**Task Force #3 – UN GTR 13 Test Procedures**

Task Force #3 – UN GTR 13 Test Procedures

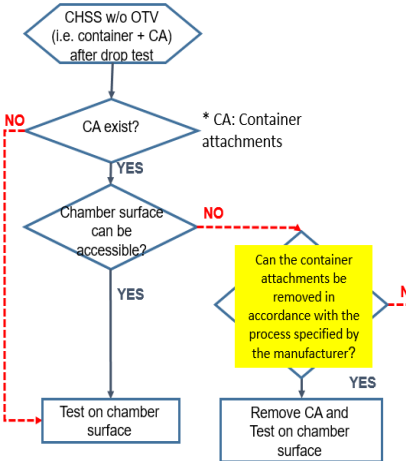
6.2.3.3.			<p>Surface damage test (unpressurized)</p> <p>The test proceeds in the following sequence:                      (a) Surface flaw generation: Two longitudinal saw cuts are made on the bottom outer surface of the unpressurized horizontal storage container along the cylindrical zone close to but not in the shoulder area. The first cut is at least 1.25 mm deep and 25 mm long toward the valve end of the container. The second cut is at least 0.75 mm deep and 200 mm long toward the end of the container opposite the valve;</p>	<p>Surface damage test (unpressurized)</p> <p>The surface damage tests and the chemical exposure tests (para. 6.2.3.4.) shall be conducted on the surface of the pressure bearing chamber of the container as long as it is accessible regardless of the existence of the container attachments.</p> <p>If the container attachments can be removed in accordance with the process specified by the manufacturer, then the container attachments shall be removed and the tests shall be conducted on the surface of the pressure bearing chamber of the container.</p> <p>Otherwise, the tests shall be conducted on the surface of the container attachments [as indicated in the flow diagram.]</p>	<p>Compared to CNG containers, which are often installed in luggage compartment for conversion, the possibility of the surface exposure to hard objects or strap or conformable container will be significantly lower because the conformable container will, in general, be designed as original equipment and more integrated into the vehicle structure.</p> <p>[Conformable container]</p>  <p>[CNG Container]</p>  <p>Position of mountings and container attachments are known by the storage manufacturer.</p>

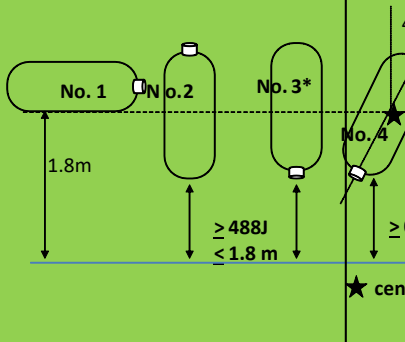
ORG	Clause/ Subclause (e.g. 3.1)	Paragraph/ Figure/ Table/ (e.g. Table 1)	Type of comment <sup>2</sup>	Comments	Proposed change	Observations/Actions	RL	Ration- ale
					<p>attached valves. The surface onto which the containers are dropped shall be a smooth, horizontal concrete pad or other flooring type with equivalent hardness. No attempt shall be made to prevent a container from bouncing or falling over during a drop test, but the container shall be prevented from falling over during the vertical drop test.</p> <p>(a) The container shall be dropped in any one of the following four orientations:</p> <p>(i) From a horizontal position with the bottom 1.8 m above the surface onto which it is dropped;</p> <p>(ii) From a vertical position with the ported end upward with a potential energy of not less than 488 J, with the height of the lower end no greater than 1.8 m;</p> <p>(iii) From a vertical position with the ported end downward with a potential energy of not less than 488 J, with the height of the lower end no greater than 1.8 m. If the container is symmetrical (identical ported ends), this drop orientation is not required;</p> <p>(iv) From a 45° angle from the vertical orientation with a ported end downward with its centre of gravity 1.8 m above the ground. However, if the bottom is closer to the ground than 0.6 m, the drop angle shall be changed to</p>			<p>t h e y e l l o w</p> <p>redline still has 1 drop. Needs to be corrected. Placeholder 1/27 Phase 2 Change #20</p>
